Docket No. 05200046

Supplemental Reply to NOV 05200046/2016-202

## **Supplemental Reply to a Notice of Violation (NOV): NRC Inspection Report No.05200046/2016-202**

DCD markups

Figure 3.8A-41 Reinforcement Arrangement of the AB MSIV House Wall (Section 2)

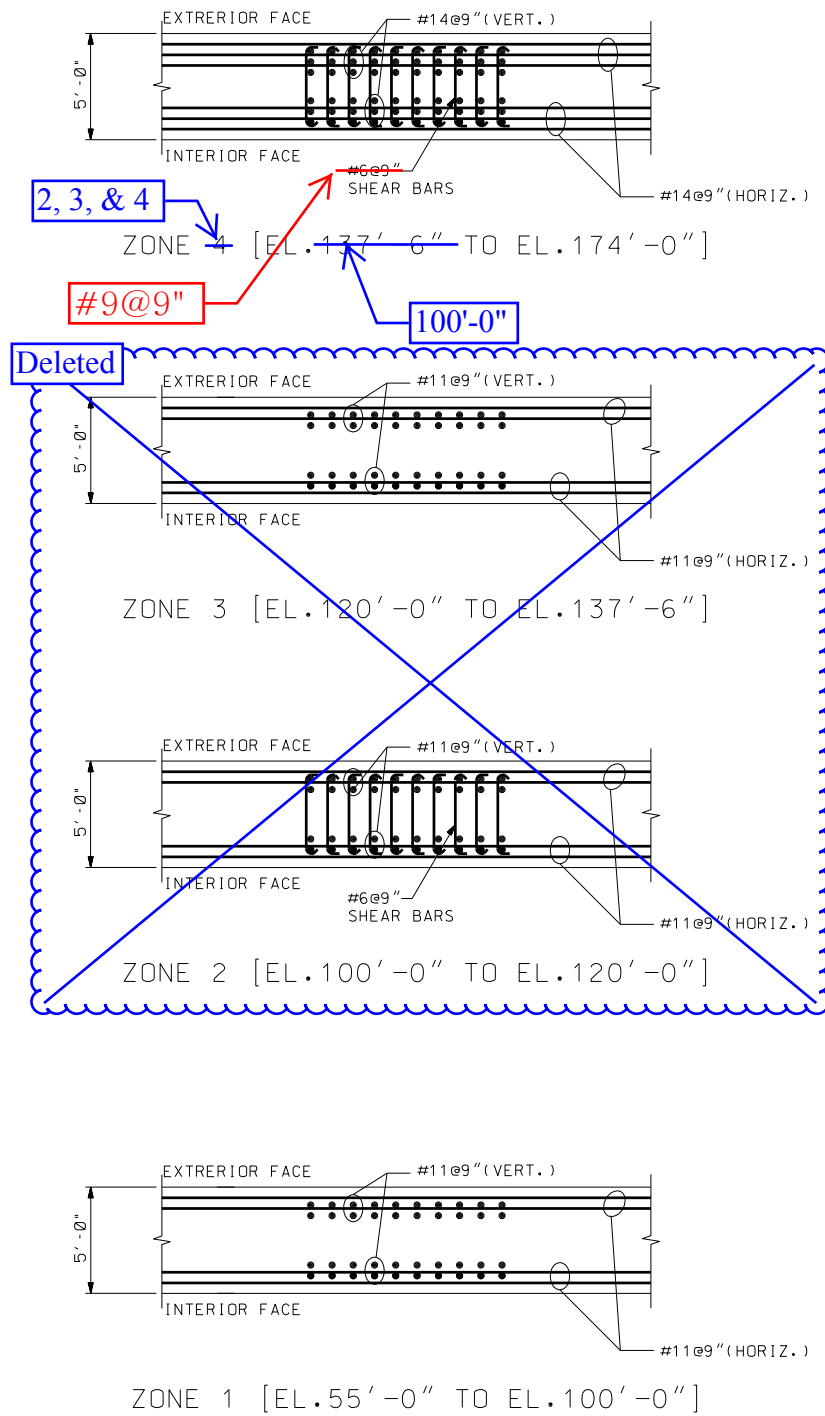
Critical Section	Zone	Elevation	Horizontal			Vertical			Shear		
			Required in <sup>2</sup>	Provided	Ratio <sup>(1)</sup>	Required in <sup>2</sup>	Provided	Ratio <sup>(1)</sup>	Required in <sup>2</sup>	Provided	Ratio <sup>(1)</sup>
North wall of north MSIV house	1	55'-0" to 100'-0"	3.6	2- #11@9"	1.16	3.23	2- #11@9"	1.29	-	-	-
	2	100'-0" to 120'-0"	3.49	2-#11@9"	1.19	3.58	2-#11@9"	1.16	0.18	#6@9"	3.26
	3	120'-0" to 137'-6"	3.23	2-#11@9"	1.29	2.76	2-#11@9"	1.51	-	-	-
	4	<del>137'-6" to 174'-0"</del>	<del>3.59</del>	<del>2-#11@9"</del>	<del>1.16</del>	<del>4.13</del>	<del>2-#14@9"</del>	<del>1.45</del>	<del>0.29</del>	<del>#5@9"</del>	<del>1.43</del>
	4 (For AIA)	137'-6" to 174'-0"		3-#14@9"			3-#14@9"			#6@9"	-
North wall of north AFWST	1	100'-0" to 137'-6"	3.16	2-#11@9"	1.32	2.97	2-#11@9"	1.40	-	-	-
West wall of MCR	1	55'-0" to 100'-0"	2.7	2-#11@12"	1.56	2.85	2-#11@12"	1.10	0.22	#5@12"	1.41
	2	100'-0" to 137'-6"	2.59	2-#11@12"	1.20	2.71	2-#11@12"	1.15	-	-	-

3	137'-6" to 156'-0"	2.39	2-#10@12"	1.06	2.03	2-#10@12"	1.25	-	-	-
	4	156'-0" to 174'-0"	1.28	#11@12"	1.22	1.51	2-#10@12"	1.94	0.27	#6@12"	1.63
	5	174'-0" to 195'-0"	1.42	#11@12"	1.10	1.13	#11@12"	1.38	-	-	-
West wall of SFP	1	114'-0" to 156'-0"	4.79	2-#14@9"	1.25	4.82	3-#11@9"	1.29	0.19	#5@12"	1.63
East wall of FHA area	1	156'-0" to 174'-0"	2.73	2-#11@9"	1.52	2.78	2-#14@9"	2.16	0.16	#7@9"	5.00
	2	174'-0" to 213'-6"	2.67	2-#10@9"	1.27	2.61	2-#11@9"	1.59	-	-	-

Figure 19.5-11 Polar Crane Bracket

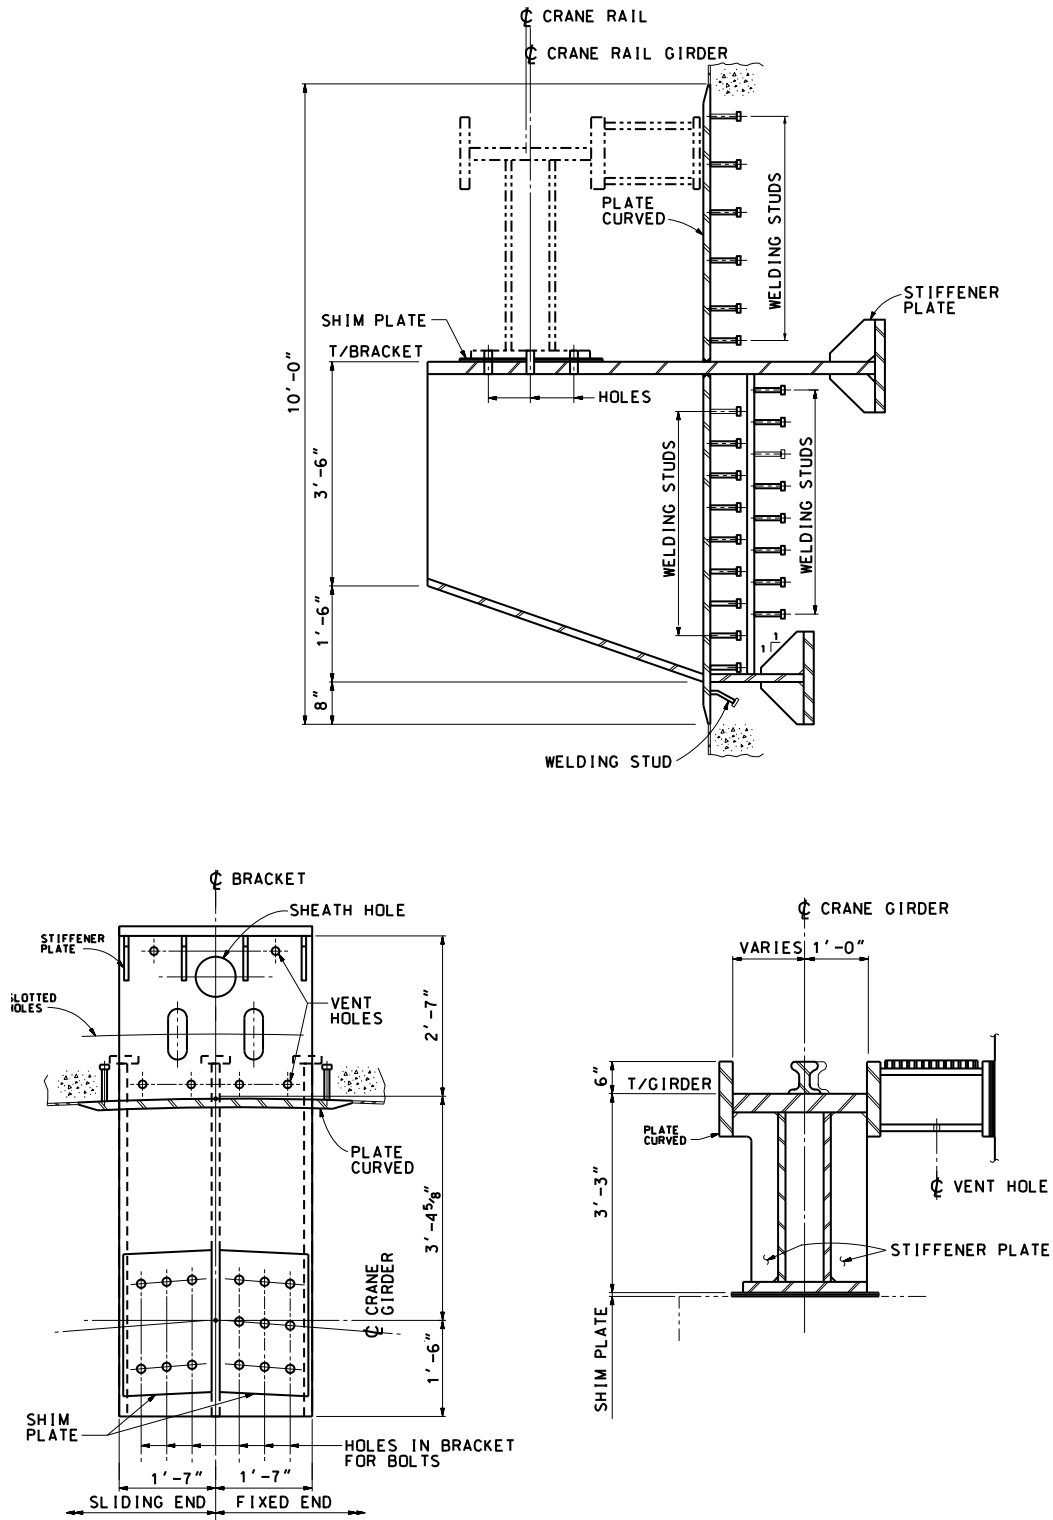
valve rooms and north/east walls of SFP area is incorporated into Section 19.5.4.2, Table 19.5-2 and Figure 19.5-12 through 13 (Refer to attachment page 12, 17, 39 and 40). The property and size of polar crane bracket and rail girder is revised to Section 19.5.4.1 and Table 19.5-1 (Refer to attachment page 11 and 16). The AIA DBDs are revised to incorporate the recently updated background General Arrangement drawing. Therefore, DCD Figure 19.5-1 ~ 19.5-10 are revised as shown in the attachment (Refer to attachment page 18 through 37).

The polar crane bracket and rail girder shown in Figure 19.5-11, are key design features to protect the safety system located inside containment from the drop of polar crane due to the impact of a large commercial aircraft. The polar crane brackets and girders shall be ASTM A588 Grade A or B and the bolts for the connection between polar crane bracket and rail girder shall be minimum 1.5" diameter ASTM A490X. The design of polar crane bracket and rail girder is performed to maintain adequate design margins. The summary of design results and material properties are shown in Table 19.5-1.
